TOWER CROSSING RETAIL - PHASE II

MCC RETAIL SUBDIVISION FILING NO. 3

TITLE: COVER

**TYPICAL PRIVATE DRIVE - EAST
@ 32ND PARKWAY**

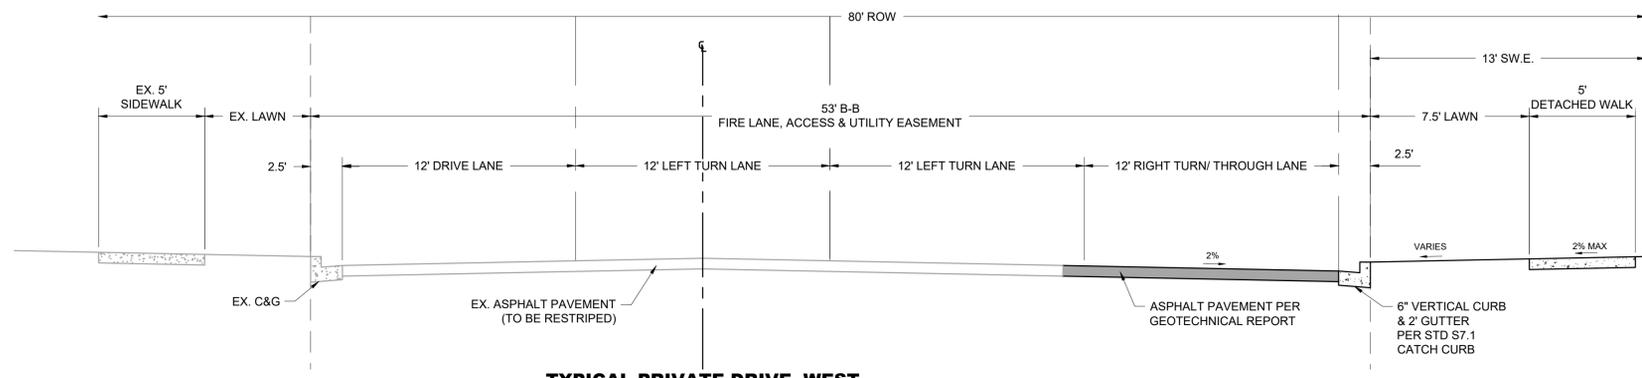
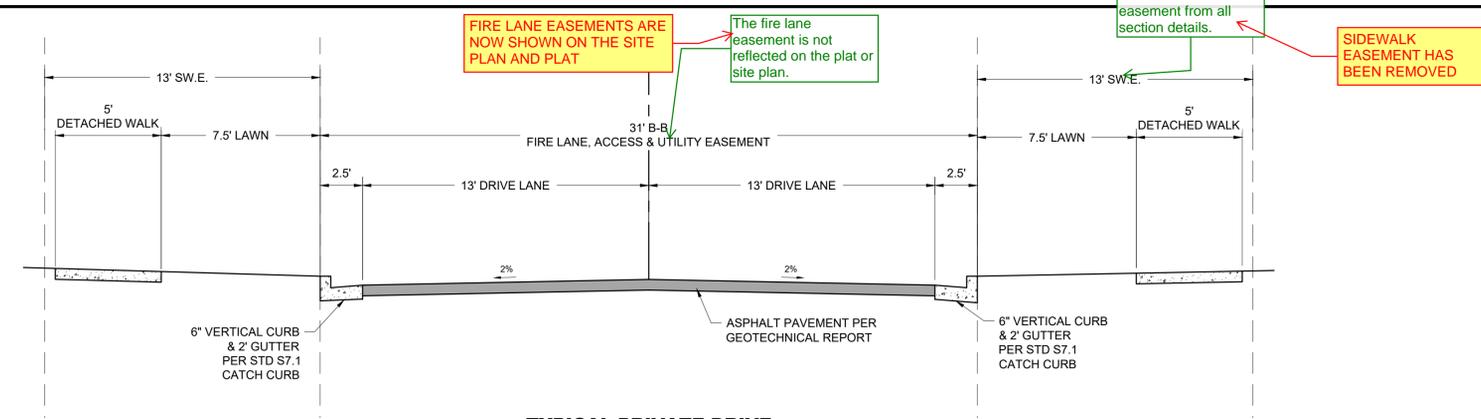
Please show the Fire Hydrants in the Roadway Sections.

FIRE HYDRANTS HAVE BEEN ADDED TO THE SECTIONS, SHOWN 3.5' FROM BACK OF CURB TO CENTER OF HYDRANT

**TYPICAL GRAVEL DRIVE
26' EDGE-EDGE**

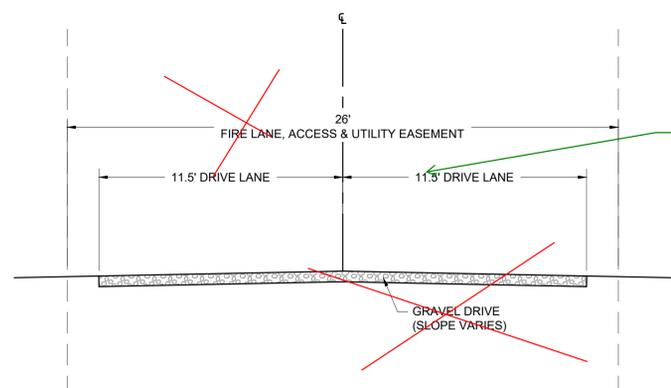
Remove the sidewalk easement from all section details.

The full width of the fire lane easement is required to be paved.

SIDEWALK EASEMENT HAS BEEN REMOVED

THE FIRE LANE ON THE SOUTHERN PORTION OF THE PROPERTY HAS BEEN REMOVED. THE ASSOCIATED SECTION DETAIL HAS BEEN REMOVED FROM THIS SHEET.

TITLE: INFRASTRUCTURE SITE PLAN
 DATE: 11.17.2023

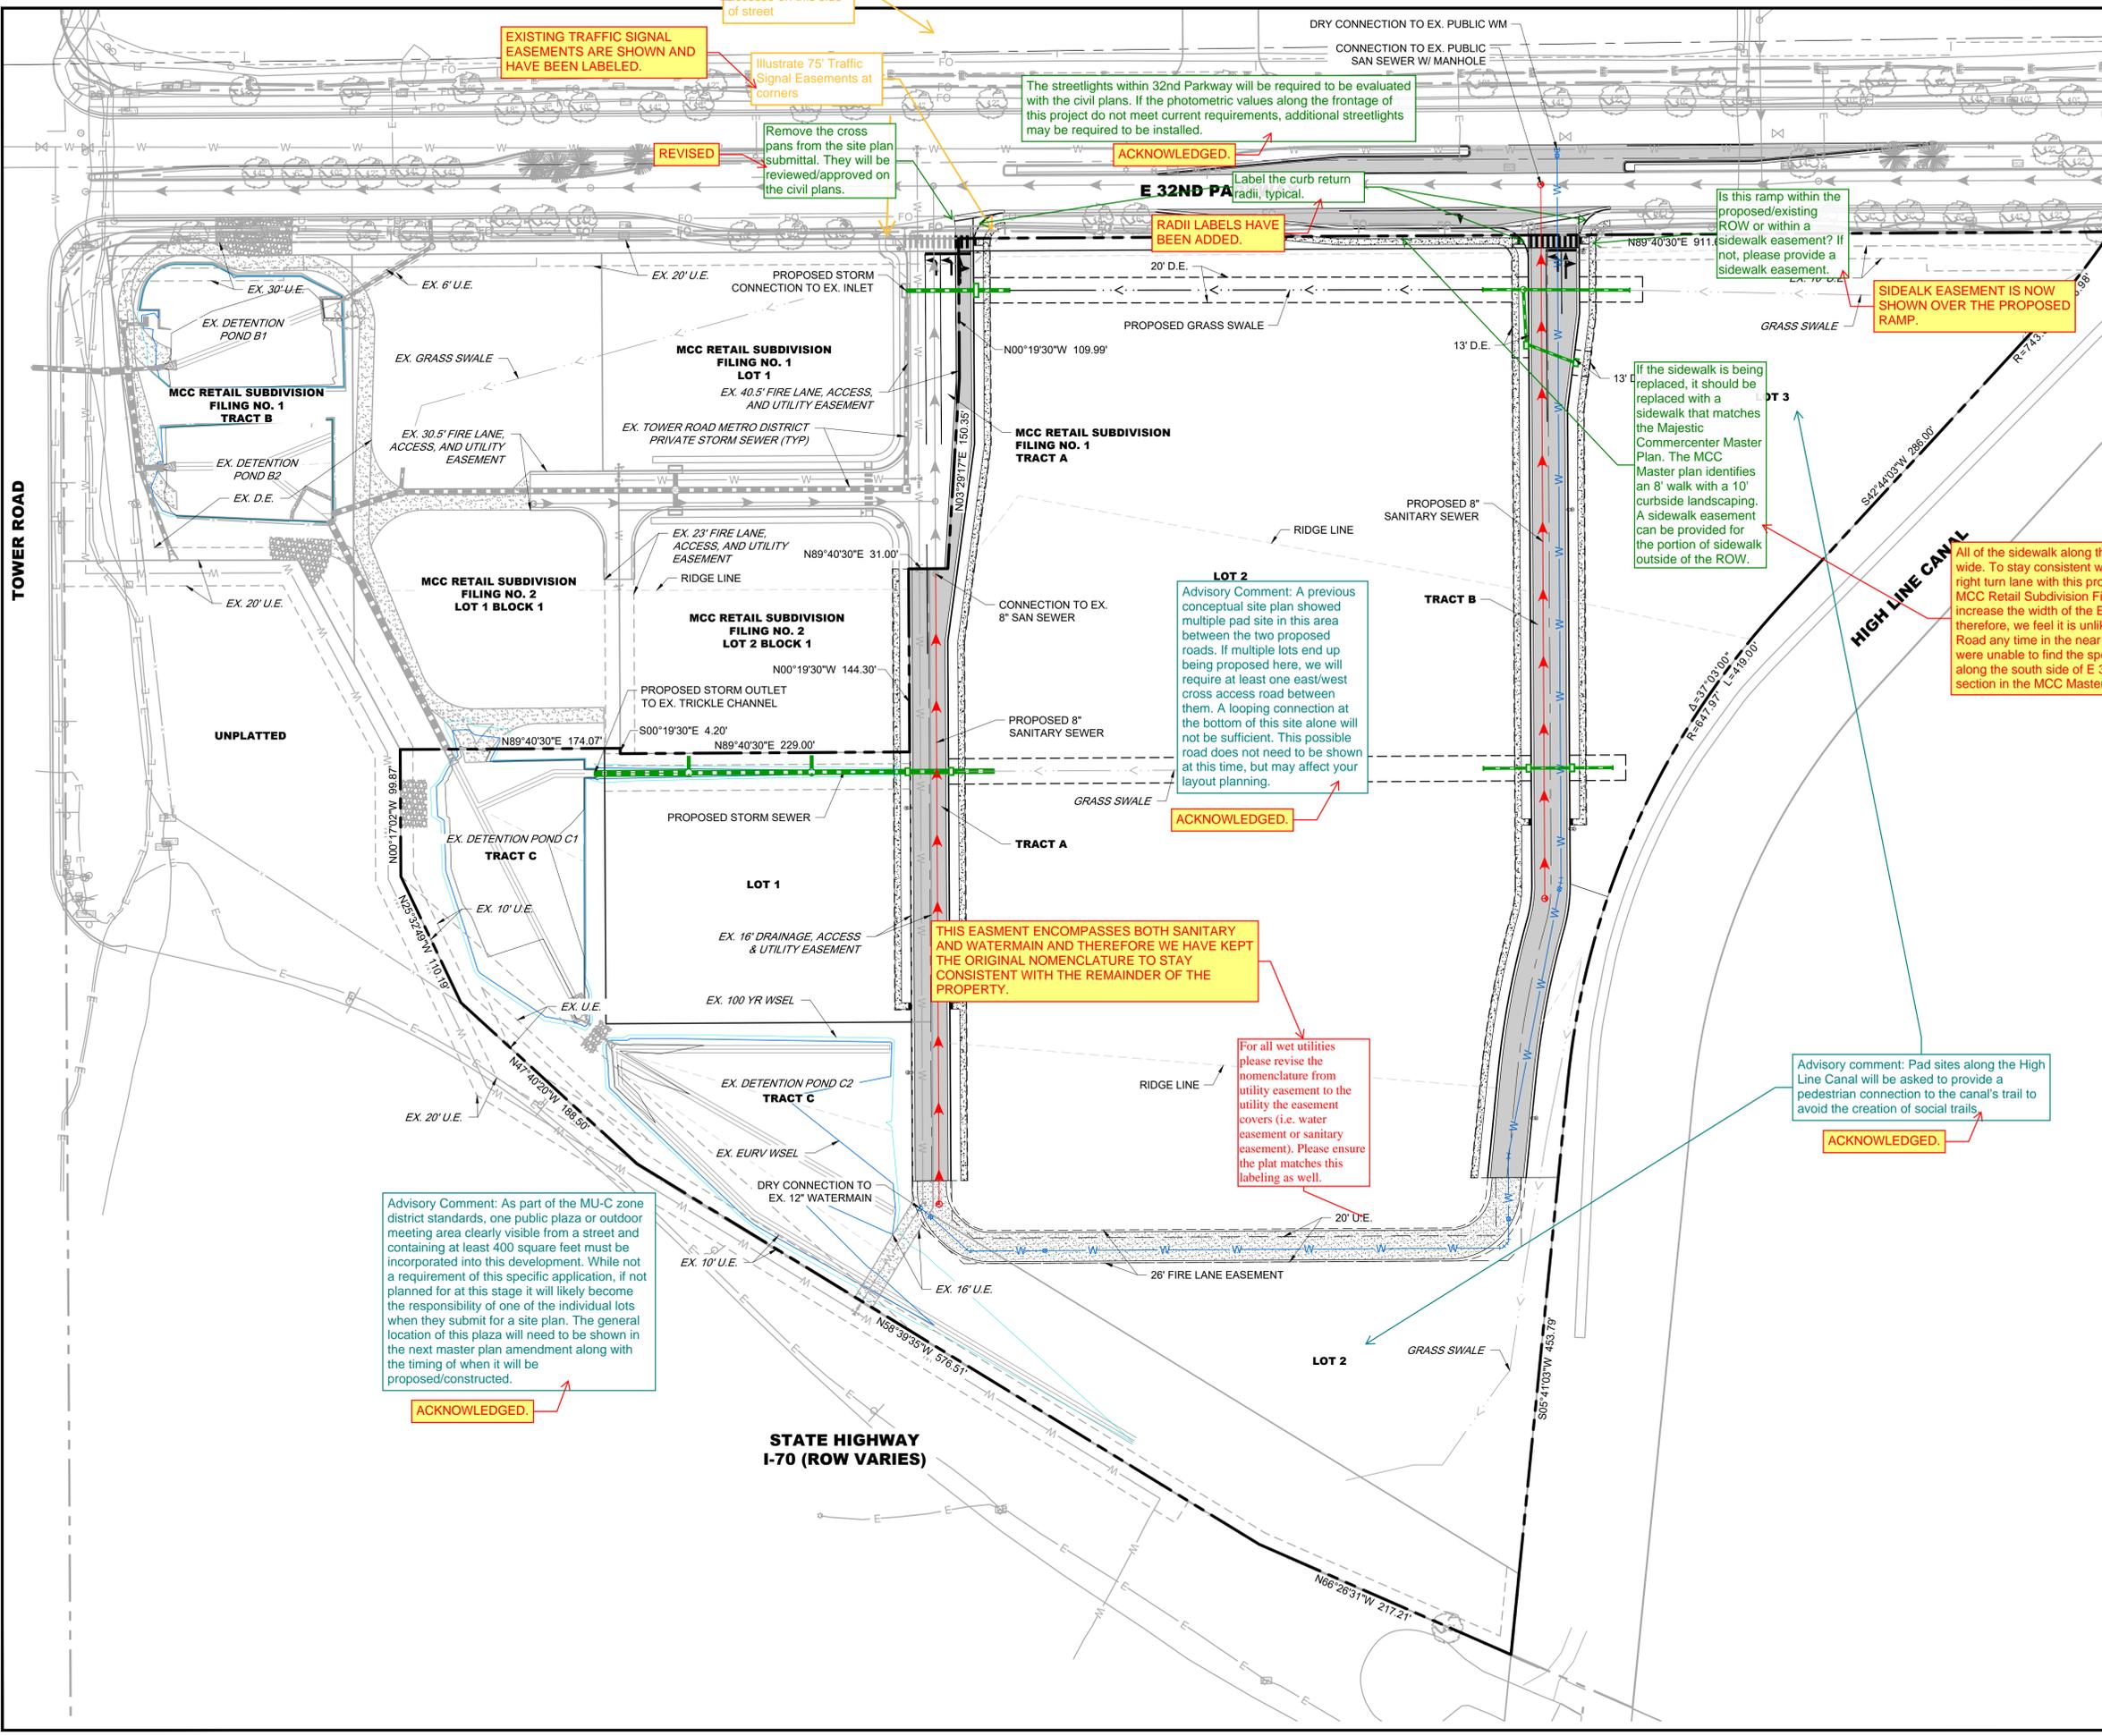
Illustrate 75' Traffic Signal Easements at corners

Label the curb return radii, typical.

Is this ramp within the proposed/existing ROW or within a sidewalk easement? If not, please provide a sidewalk easement.

If the sidewalk is being replaced, it should be replaced with a sidewalk that matches the Majestic Center Master Plan. The MCC Master plan identifies an 8' walk with a 10' curbside landscaping. A sidewalk easement can be provided for the portion of sidewalk outside of the ROW.

For all wet utilities please revise the nomenclature from utility easement to the utility the easement covers (i.e. water easement or sanitary easement). Please ensure the plat matches this labeling as well.

Please add the following note: "Private street lights will remain privately owned and maintained in perpetuity."

EXISTING TRAFFIC SIGNAL EASEMENTS ARE SHOWN AND HAVE BEEN LABELED.

RADI LABELS HAVE BEEN ADDED.

SIDEALK EASEMENT IS NOW SHOWN OVER THE PROPOSED RAMP.

All of the sidewalk along the south side of East 32nd Parkway currently is 5' wide. To stay consistent with this, the small portion being reconstructed for the right turn lane with this project has been left at 5'. The final engineering for MCC Retail Subdivision Filing No. 1, Lot 1 (Freddy's) was not required to increase the width of the E 32nd Parkway sidewalk along it's frontage to 8', therefore, we feel it is unlikely that the 8' walk will be continued out to Tower Road any time in the near future. In addition, we may have missed it but we were unable to find the specific requirement for a 10' tree lawn and 8' walk along the south side of E 32nd Parkway - can you point us to the relevant section in the MCC Master Plan?

THIS EASMENT ENCOMPASSES BOTH SANITARY AND WATERMAIN AND THEREFORE WE HAVE KEPT THE ORIGINAL NOMENCLATURE TO STAY CONSISTENT WITH THE REMAINDER OF THE PROPERTY.

NOTE HAS BEEN ADDED

SHEET NUMBER
L-1
1 OF 5

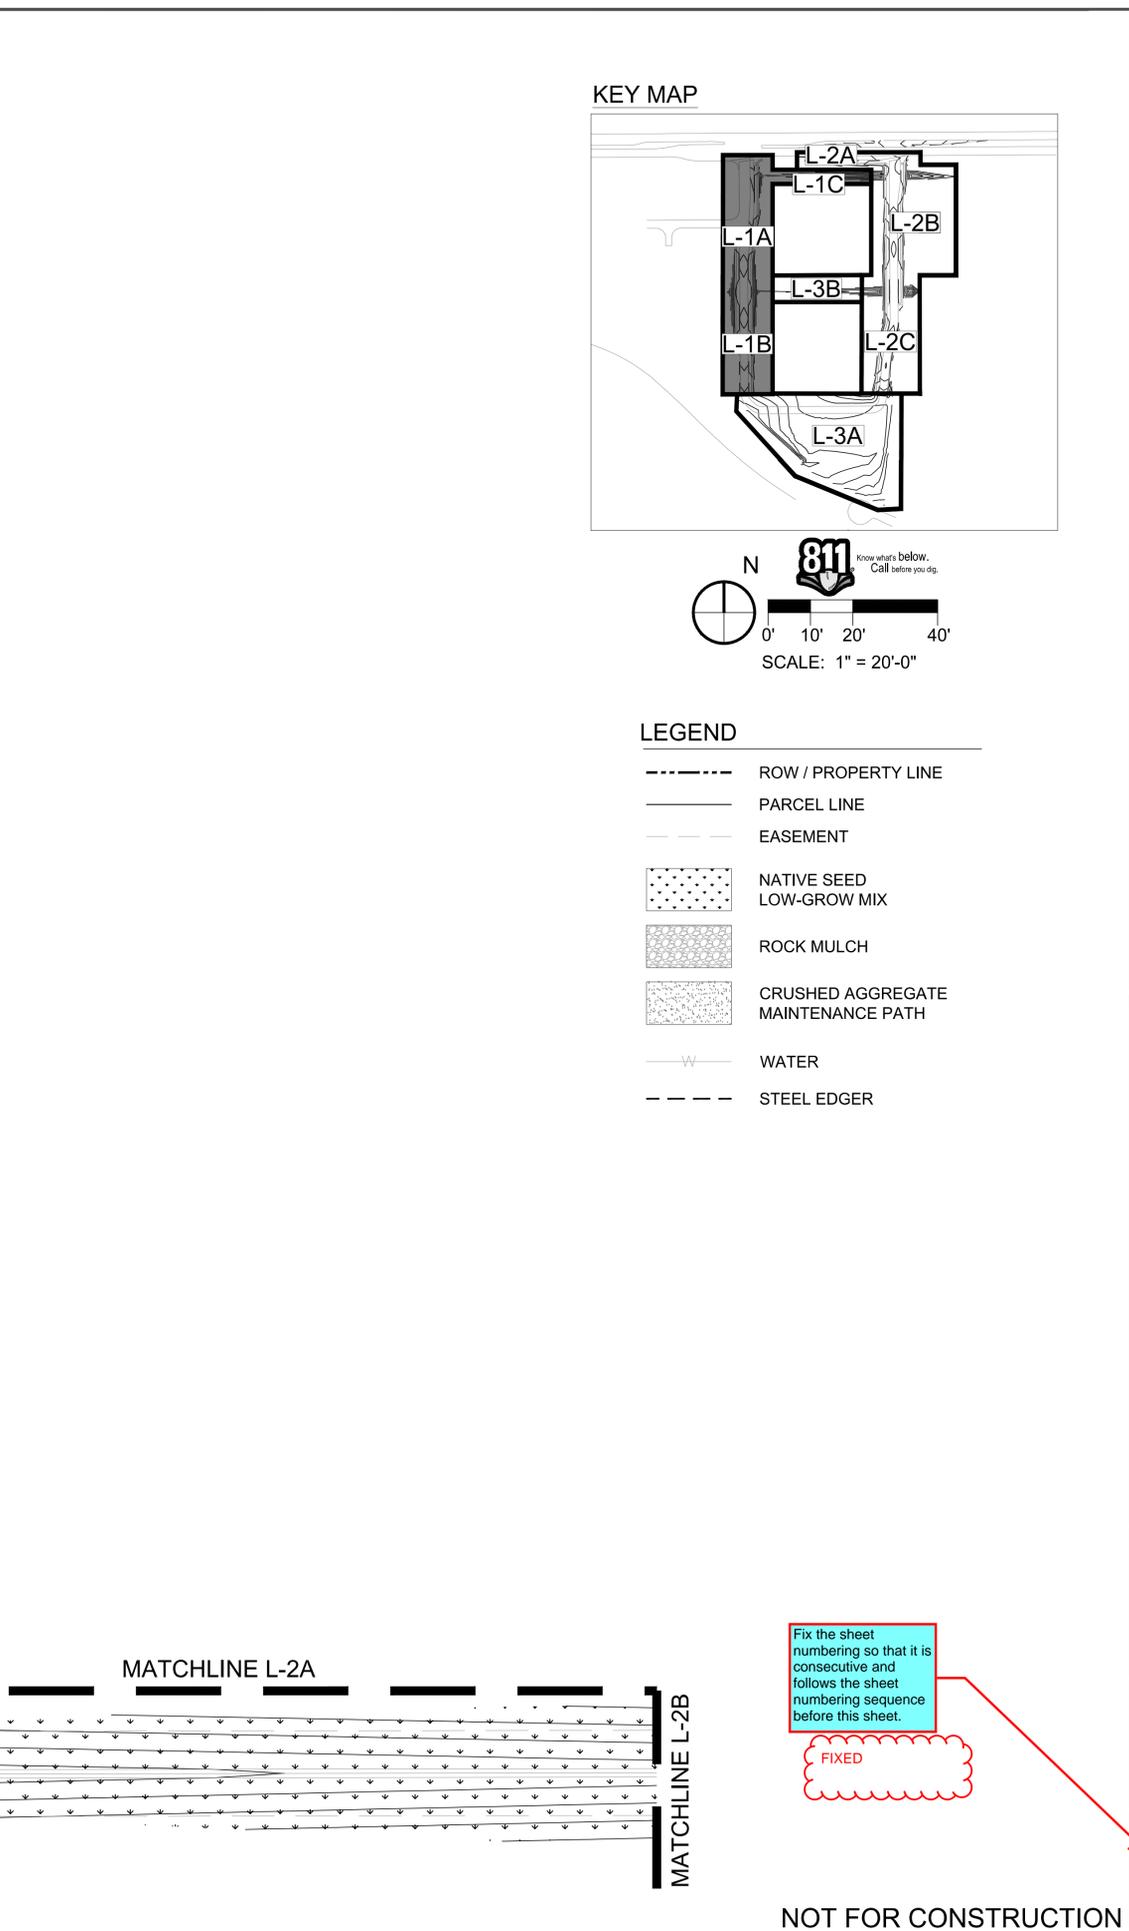
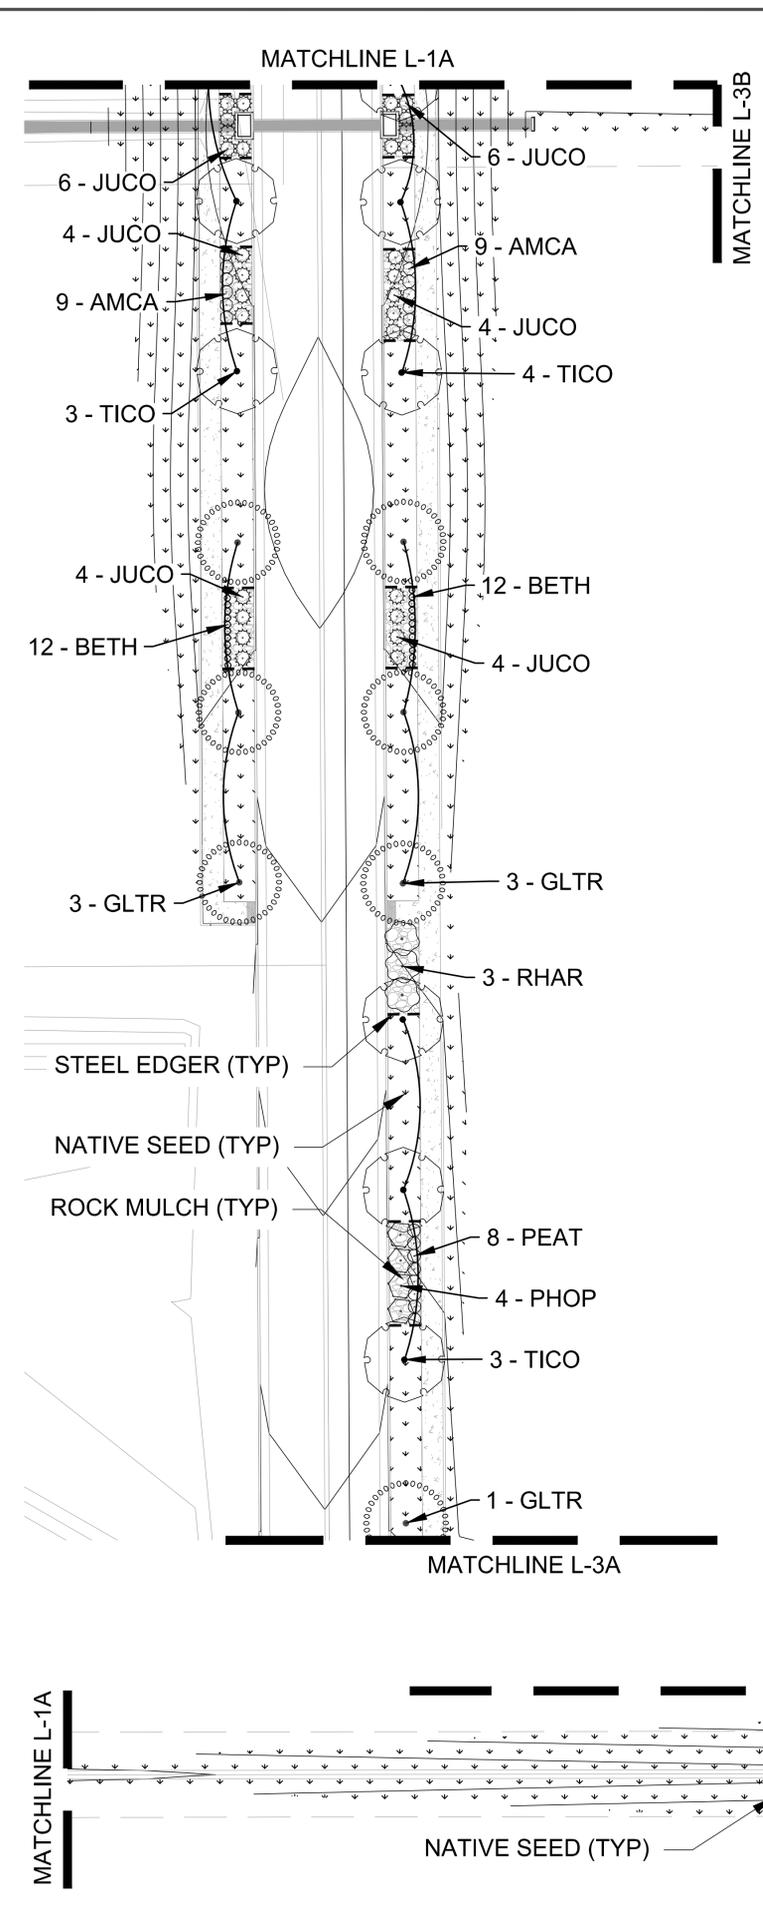
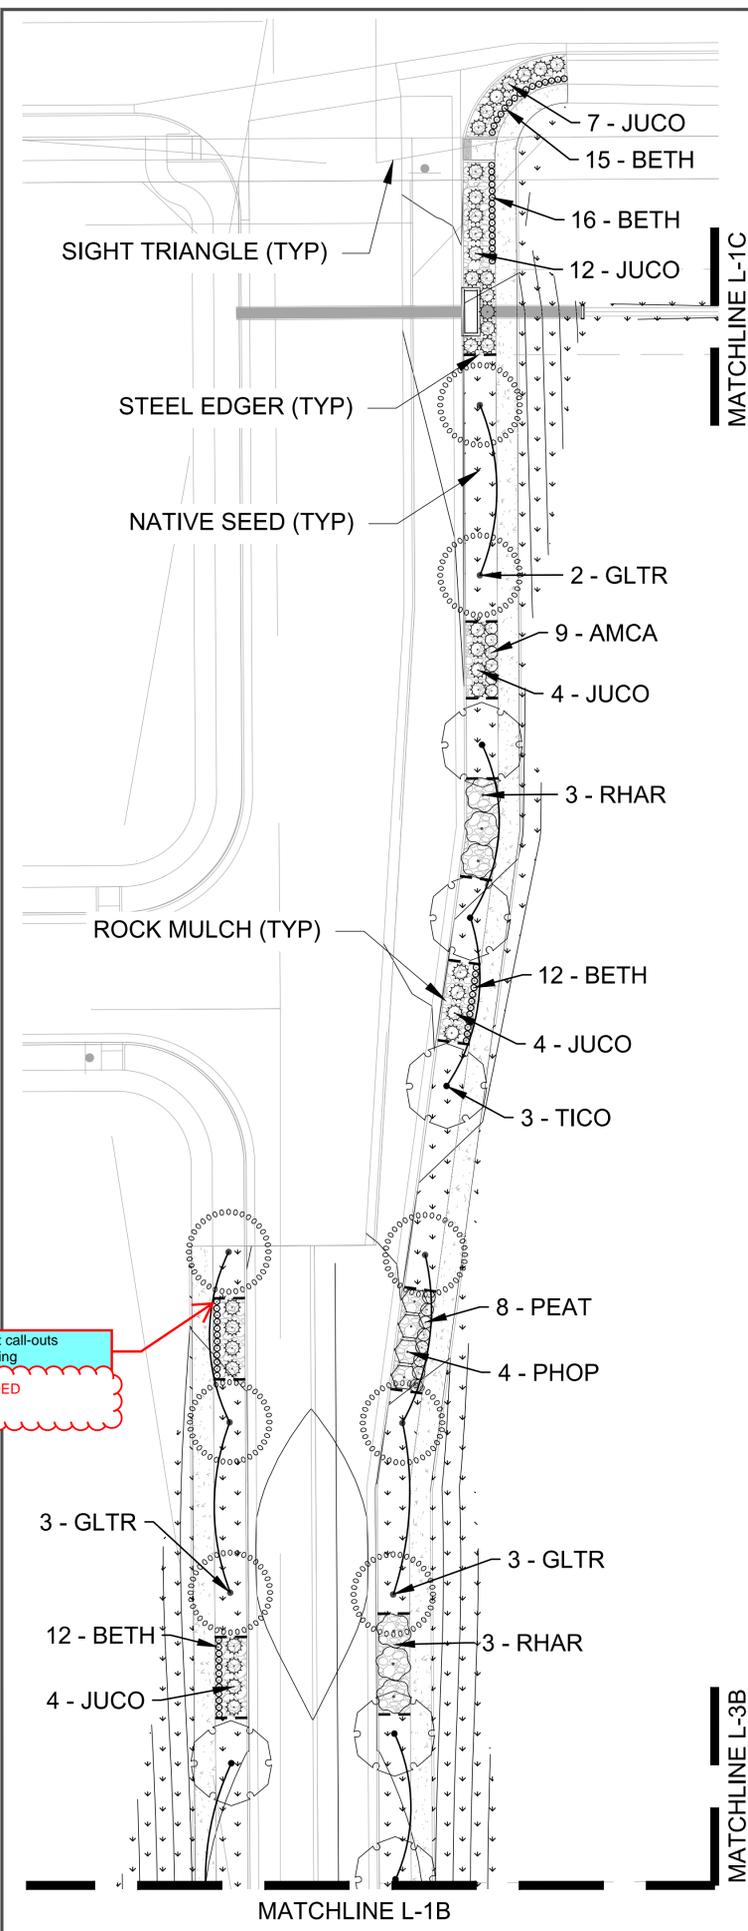
Plant call-outs missing
ADDED

Fix the sheet numbering so that it is consecutive and follows the sheet numbering sequence before this sheet.
FIXED
